TELEX CIRCUIT 1500 P.P.S.

TG(L) 3501
3 · 8 · 1938

MODIFIED ALARM CCT., TO PROVIDE CALLING FACILITY FOR TELEPHONE CCT. & ALTERNATIVE BELL OR LAMP SIGNAL.

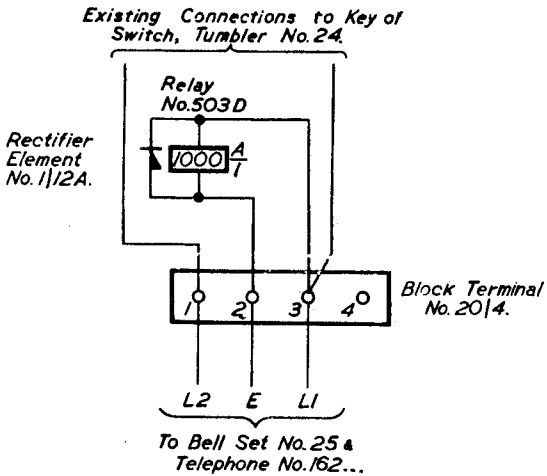
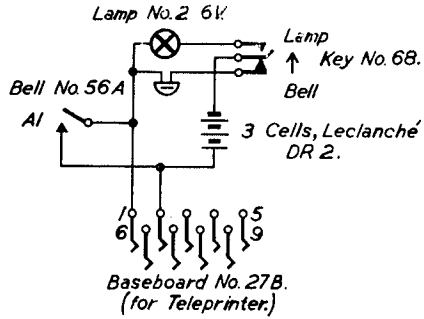
1. Baseboard No. 27B to be fitted in place of Baseboard No. 27.
2. Key, No. 68, Black, Jack, Lamp No. 39, Relay No. 503 D. & Rectifier Element No. 1/12A, to be fitted in Baseboard No. 27B.
3. For Telex. Cct. see TG(L) 996.
